Access Compliance Report Public Rights-of-Way (Curb Ramps)

Main Street: NARROW_CANYON_RD Cross Street: ETHEREAL_RD Location: W

ADA ID: RPRK211027135236 Ramp Type: Type 1 - Perpendicular Initial Pass/Fail: Fail Overall Compliance: No Severity Score: 15

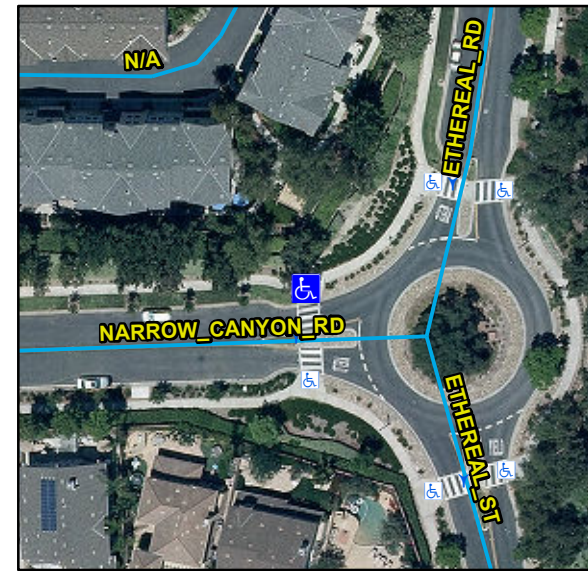
R304.2.2, R204.3, STD 1115

Remove & Replace Entire Ramp.
